EPA COMMENTS

DRAFT FINAL REMEDIAL INVESTIGATION REPORT
HOMESTAKE MINING COMPANY SUPERFUND SITE

Operable Unit 1 – Tailing Seepage and Contamination of Groundwater Aquifers
Operable Unit 2 – Long-Term Tailings Stabilization, Surface Reclamation and Site Closure

Dated: September 30, 2019

Figure 1 – Hydraulic Conductivity of the Alluvial Aquifer
(from Figure 3.2.2-4 of 2012 Corrective Action Plan)

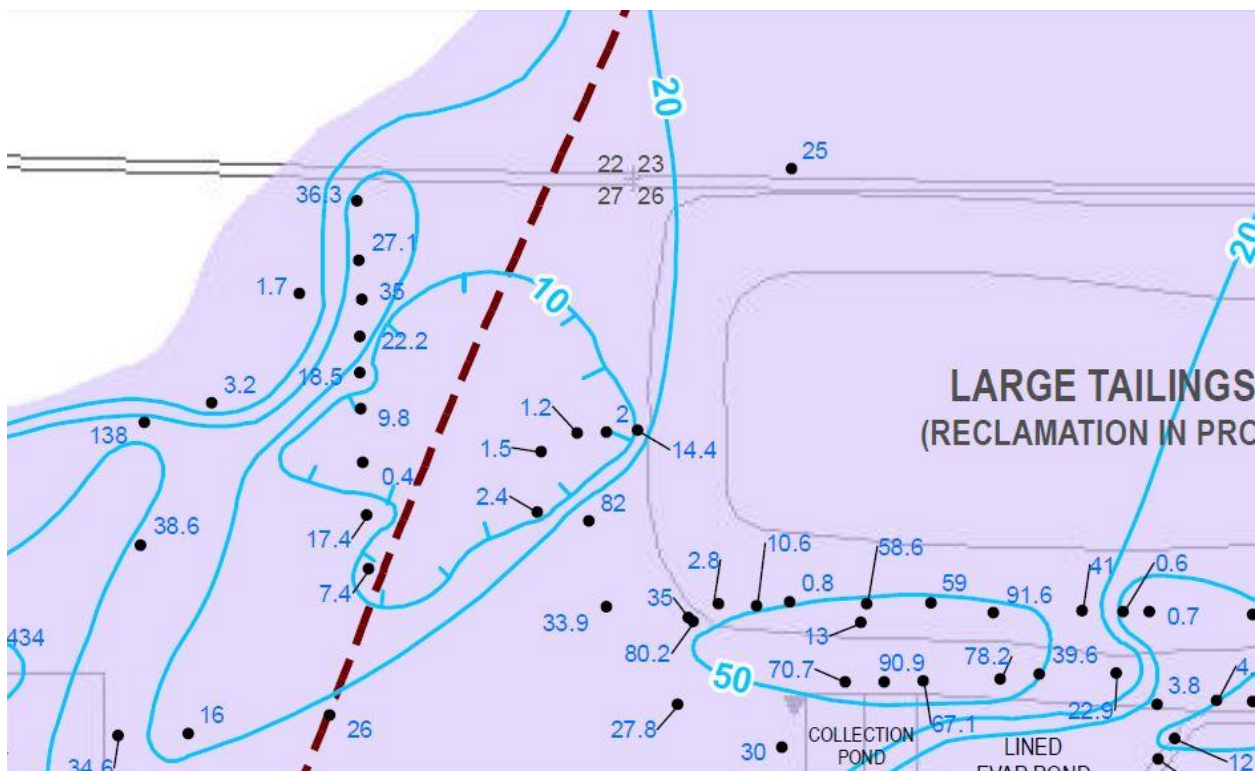
- b. EPA does not understand the reference to Figure 1-4 in the forth paragraph on page 2-7. Please verify it is the appropriate referenced figure and revise if it is not.
- c. Please revise the fifth full paragraph on page 2-7 to discuss the relatively low hydraulic conductivities in the area south of the bedrock ridge at BK4. Hydraulic conductivity values range from 0.4 feet/day to 14.4 feet/day. These low values appear to be in the area of the bedrock ridge based on mapping of the base of alluvium structure. See Figure 1, below.

Figure 2

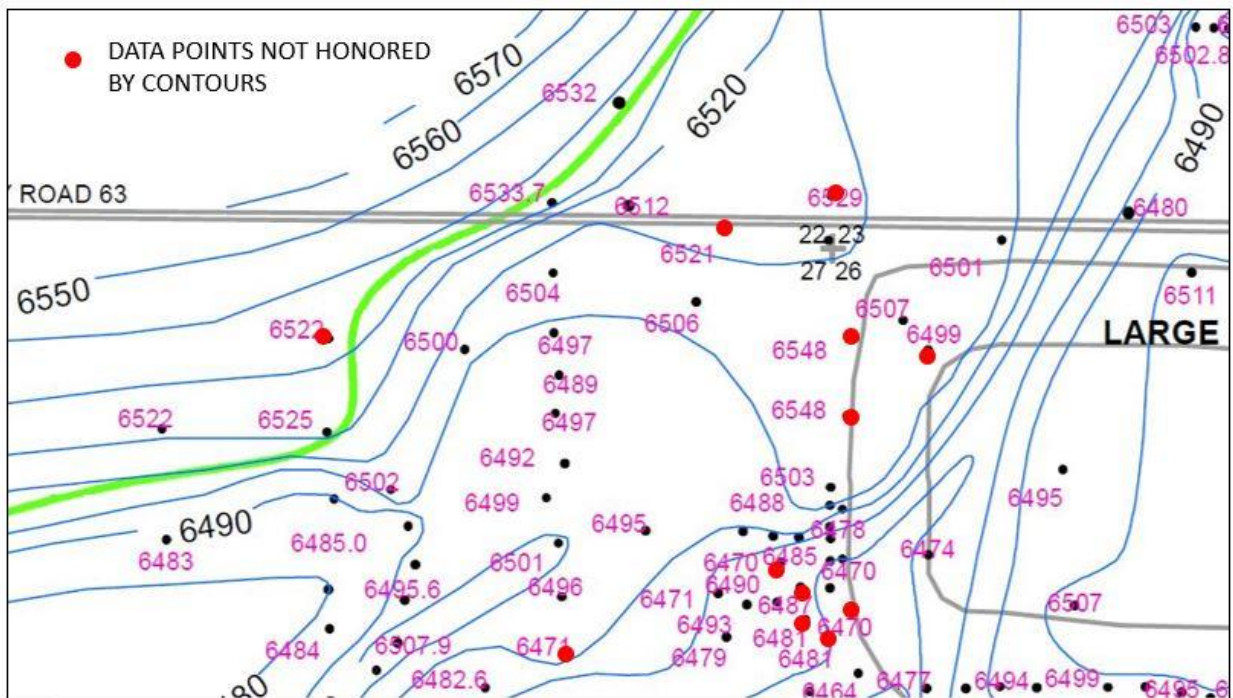
13. Figure 2-21 – Base of Alluvial Contour Map

The base of alluvium structure contour map still does not honor the data points at many locations. See Figure 2, below, which shows the well data points not honored by the contour lines in the area of BK4. As an example of a mapping effort that honors the data points, EPA has recontoured the area near BK4 (see Figure 3 below). EPA has previously requested that this area of the Site be recontoured using the Supplemental Background Study data, as well as any additional geologic boring data that may have been collected, and at a larger scale to show better detail of the base of alluvium structure. Such mapping should help delineate the bedrock ridge encountered at BK4.
